RE: Project Status Log – 11-27-2019

**TOWN OF FARMINGTON PLANNING BOARD
DELAWARE RIVER SOLAR PROJECT
FULL ENVIRONMENTAL ASSESSMENT FORM PART 2
SUPPLEMENTAL NARRATIVE TO APPLICANT**

**REVISED NARRATIVE FOR AMENDED
NEGATIVE DECLARATION - November 26, 2019**

**Re: Review of Lakeside Engineering Comment Memo
Delaware River Solar LLC Solar Energy Facility Project – Yellow Mills Road
Town of Farmington, Ontario County, New York**

Figure A – Solar Panel Array Cross Section: Array Spacing is depicted to show disconnection of flow path between arrays. *Source: Maryland Department of the Environment*

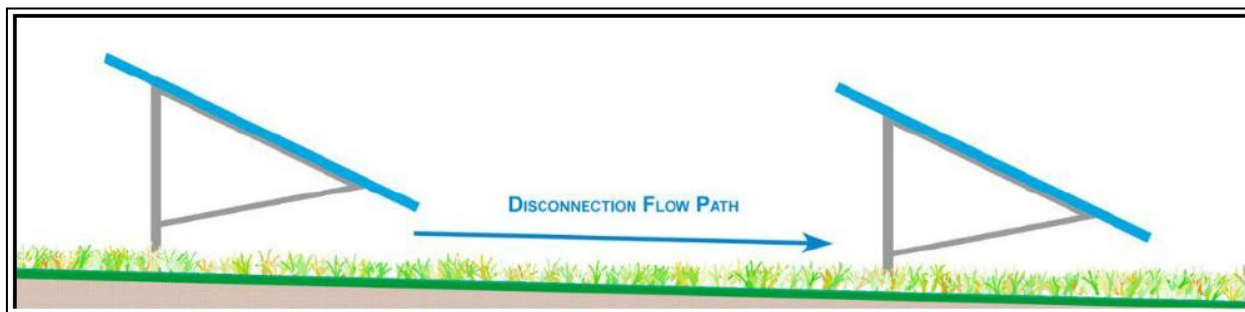
Request: Provide mitigation details for maintaining water quality on this site.

Water quality will be maintained through the Post Construction Stormwater Management function of the SWPPP. The NYSDEC has determined that solar energy systems are considered a pervious surface when calculating stormwater quality. This is due in part to being able to “disconnect” the solar panel surfaces from the vegetated surfaces located below the modules and in the rows of spacing between the modules. The solar arrays are elevated above the ground at a minimum height of 3 feet and rise at an angle to approximately 8 feet tall, and therefore are “disconnected” and independent from vegetated surfaces, which sit below and are wider than the row of panel arrays. This means there is more area under the panel arrays, than is covered by them, and no area of ground surface is physically covered by panel arrays. See **Figure A** below for a cross section view of how solar panel arrays are constructed above the surface of land. Rainwater can fall underneath panel arrays, and flow similarly to how it would if there were no panel arrays present. Panel arrays also act to break the velocity of rain droplets as they fall from the sky. Slower rain droplets then roll off the panels onto the vegetated ground surface, where they are better absorbed at lower velocity.

Stormwater quality is therefore treated by capturing the runoff from impervious surfaces such as the access road, and the concrete pad where the inverter and transformer are located adjacent to the access road. For this solar energy system, the water quality requirements can be met by using Bioretention areas to treat the runoff from the access roads.
